Sign Package for: **Mechanics Cooperative Bank**  
1238 Kempton Street, New Bedford, MA

**January 3, 2020**

**DOUBLE FACE  
PYLON SIGN**

19-1487-1A

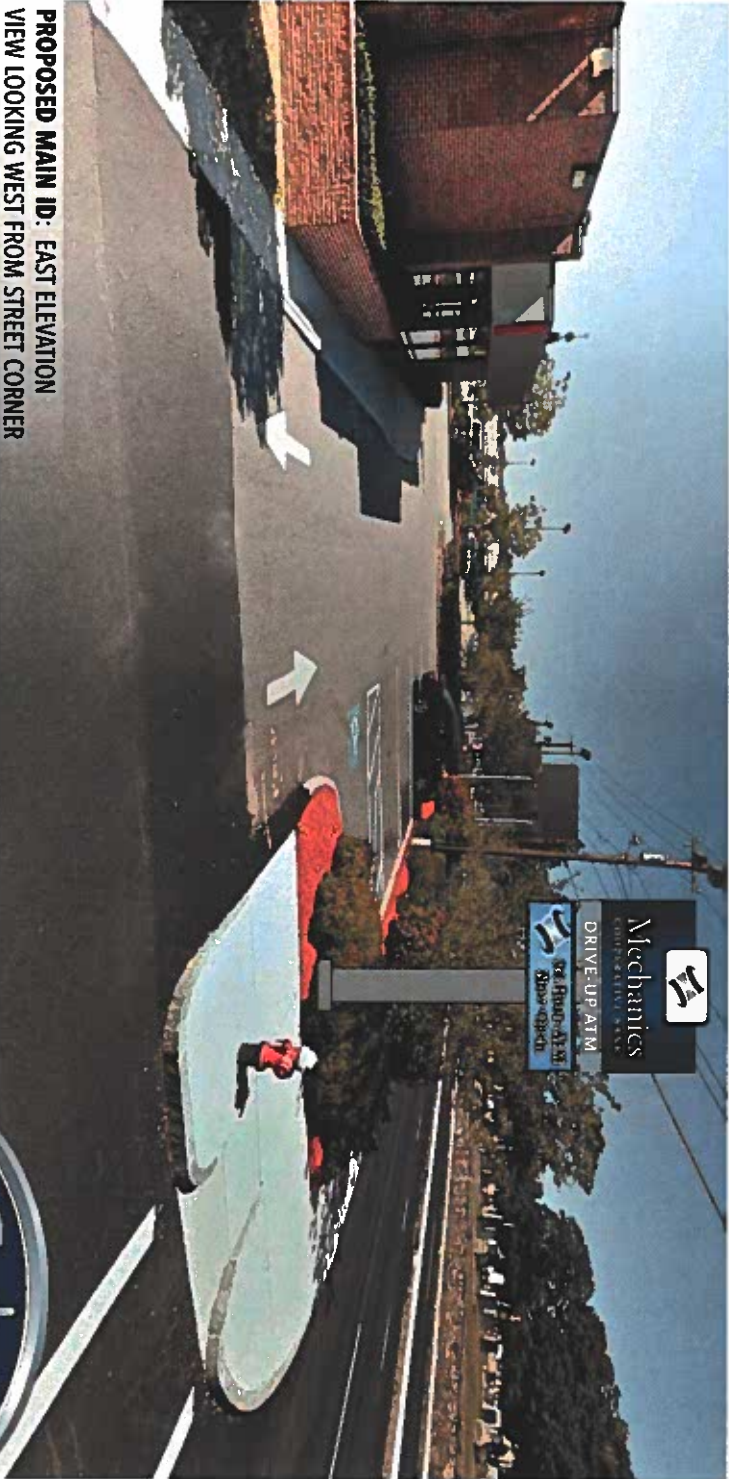
Proposed sign design presented at the March 11, 2020 Planning Board Meeting. The Planning Board provided conditional approval to include the following revisions:

1. Reduce the overall height of the sign by 1' from 18' 10" down to 17' 10"
2. Remove white, center section that extends past the top of the sign cabinet

19-1487-1D

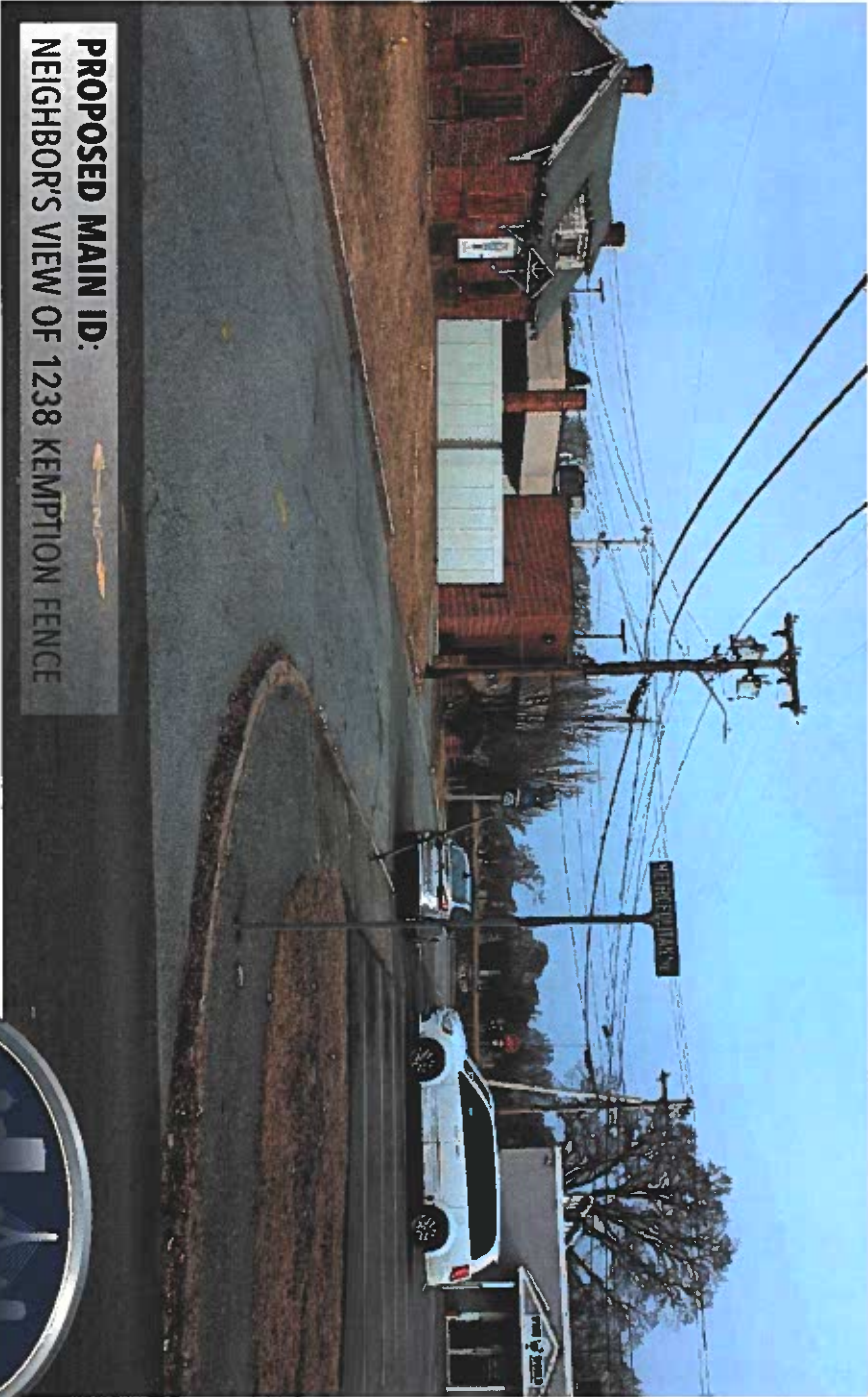
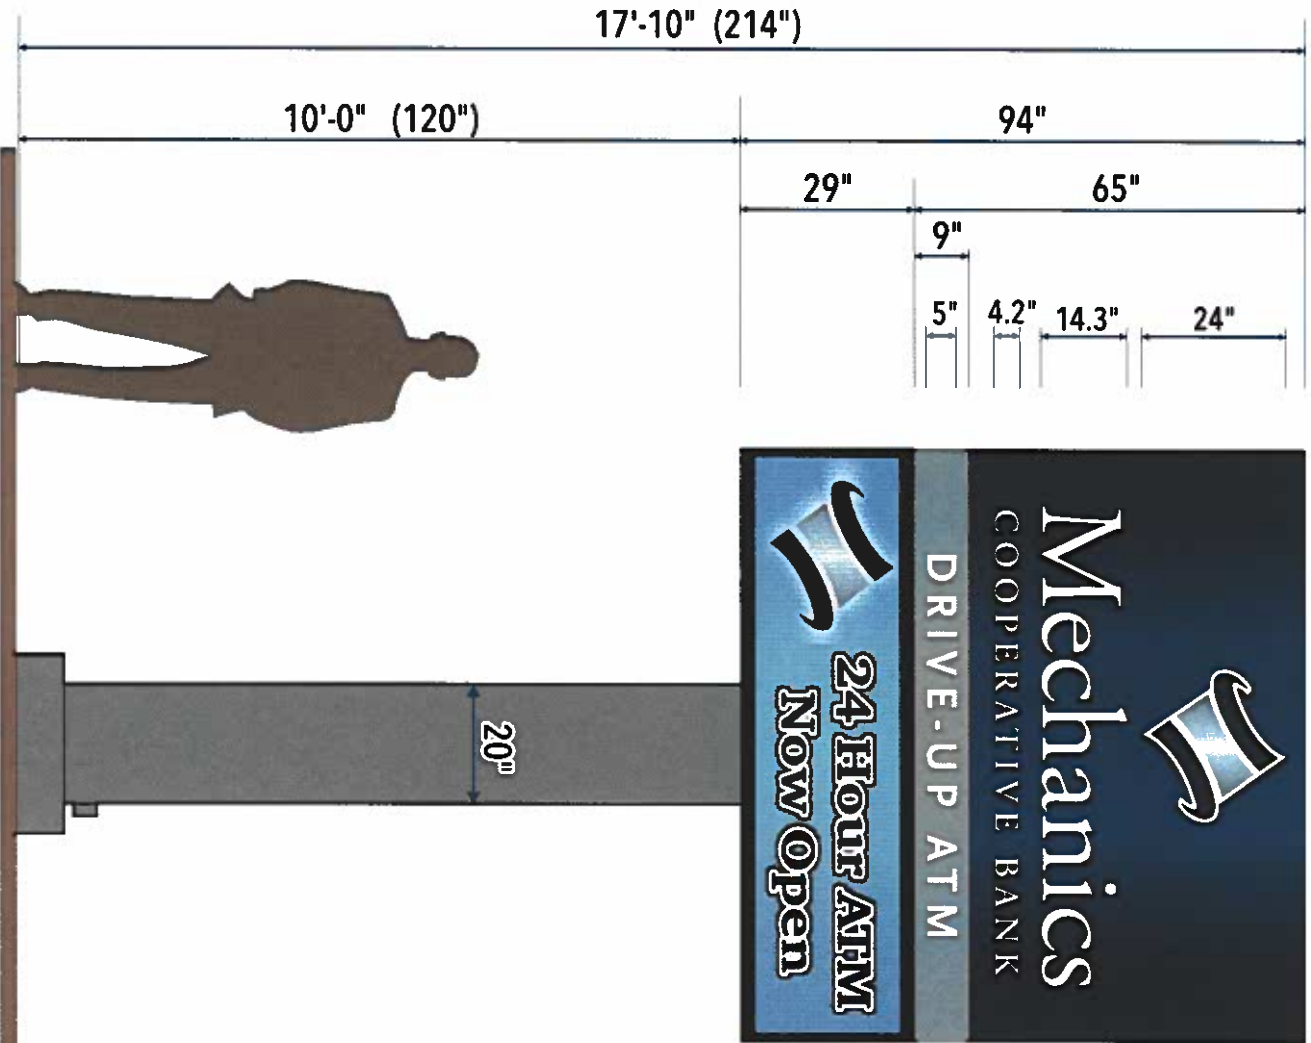
Revised sign design including the Planning Board's requested revisions made at the March 11, 2020 meeting.

Sales: Adam Brodeur  
Design: P.Mig:  
Drawing #: 19-1487-2

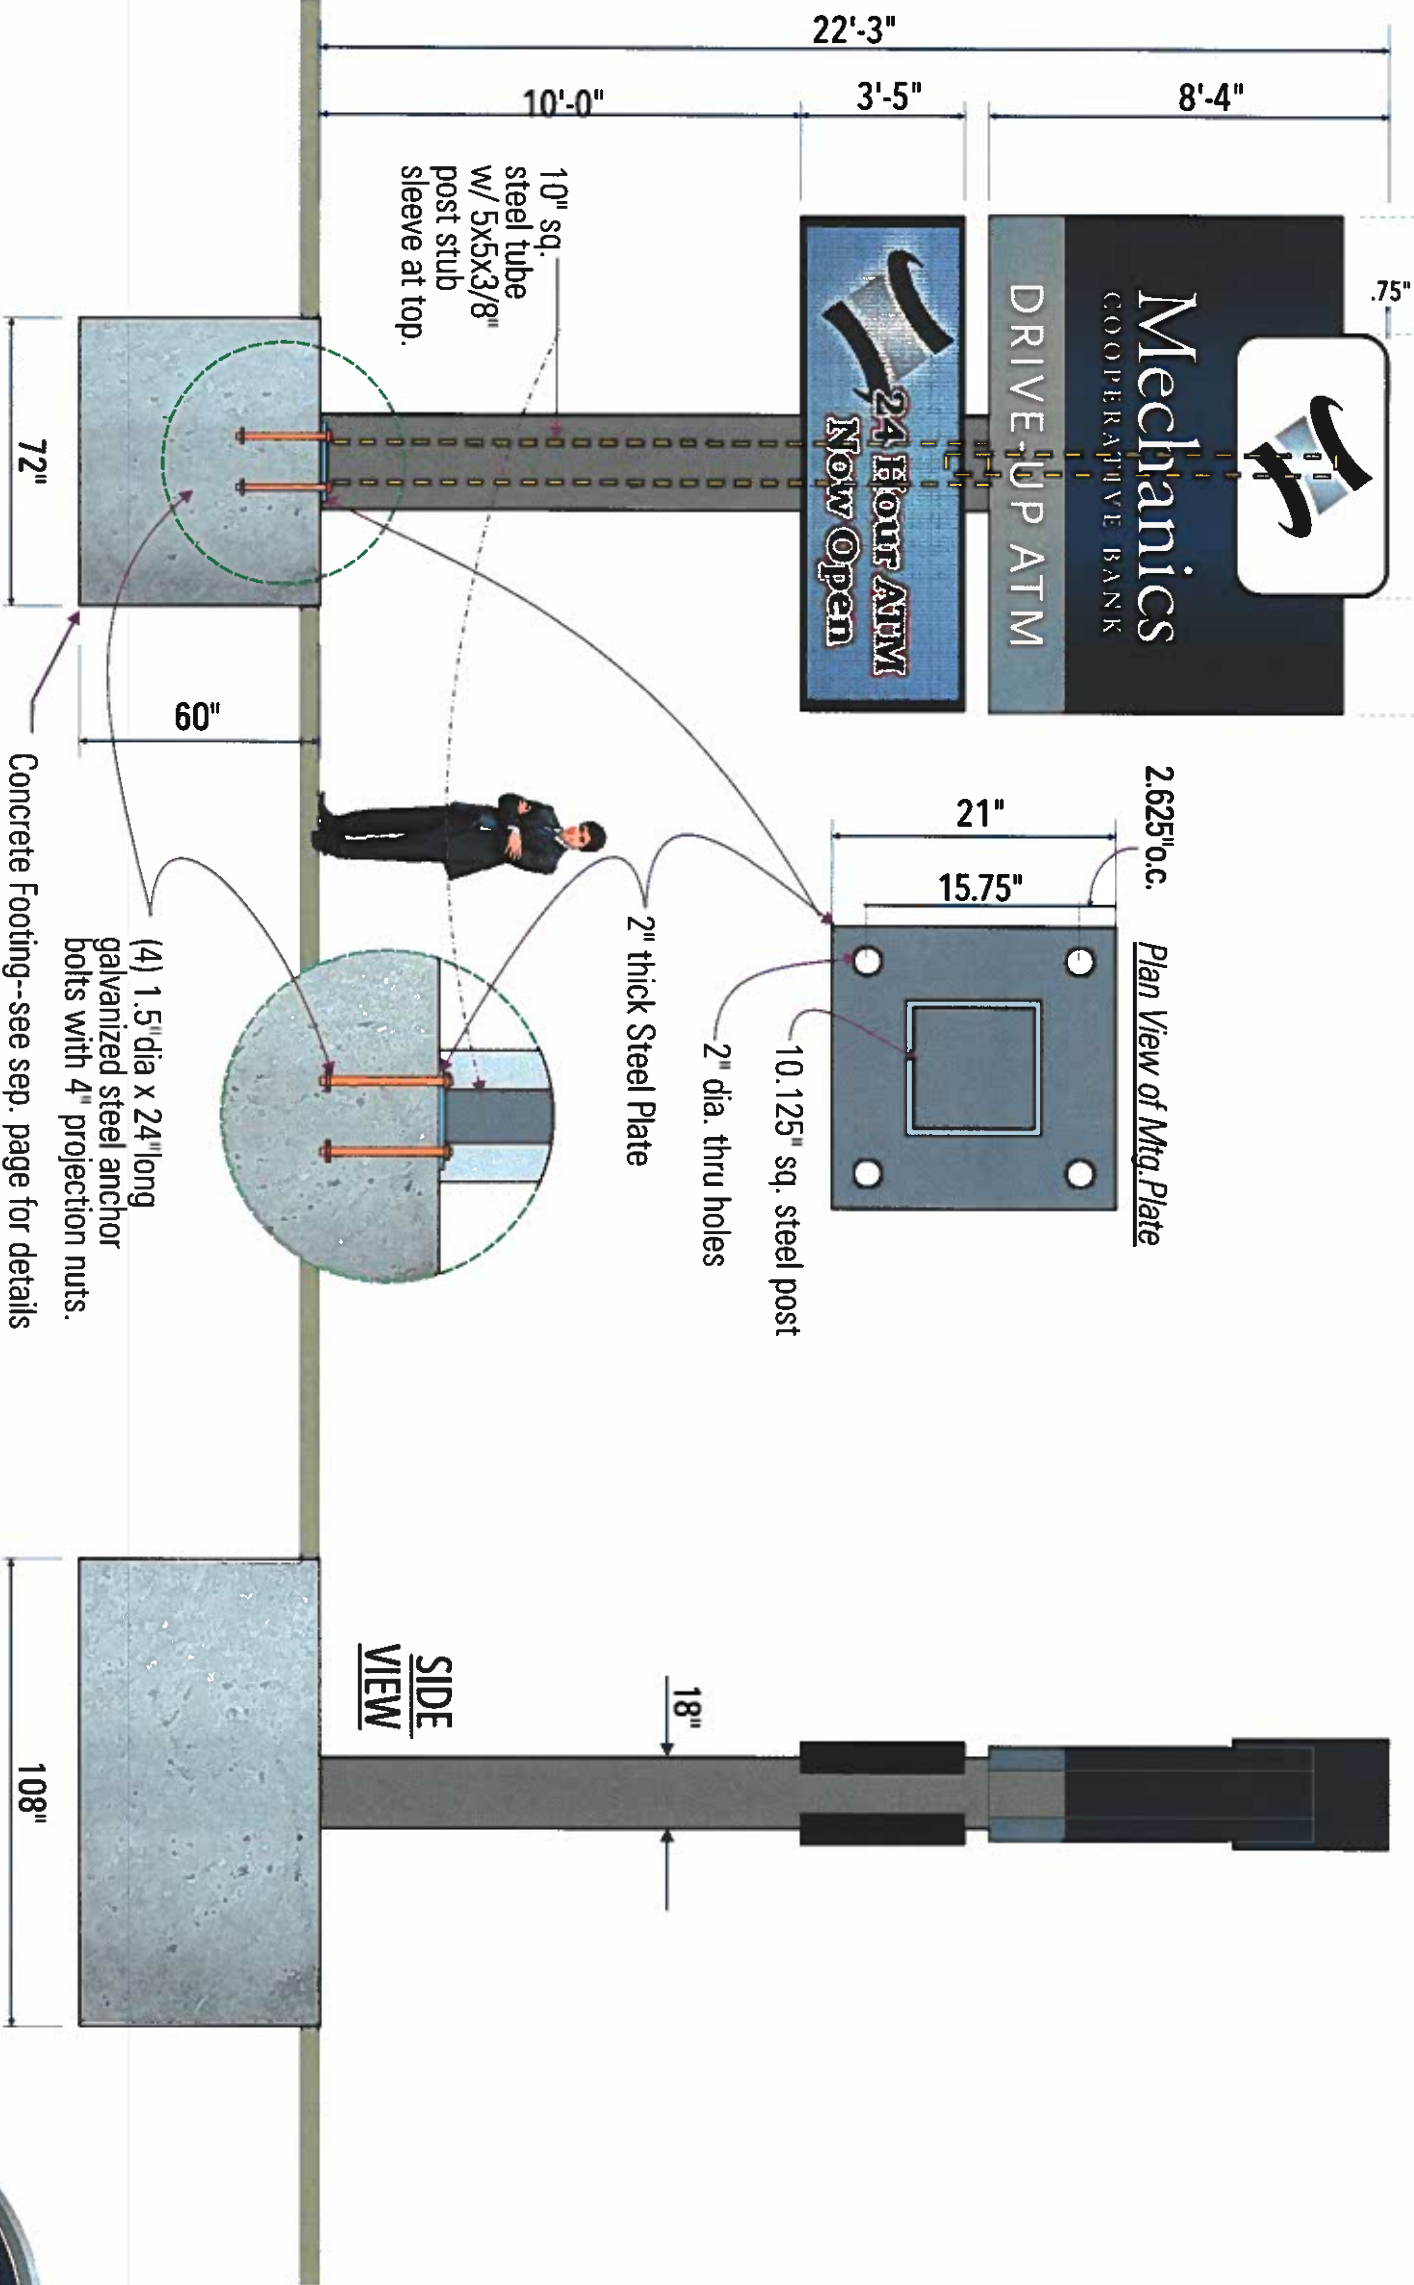
Sign fabrication and structural building plan to remain as drawn below although design/dimensions of the sign were reduced at the request of the Planning Board on March 11, 2020. Total sign square footage to be 64.6 square feet and sign to be 17' 10" tall. Please refer to page 3 for the final proposed sign design/dimensions.
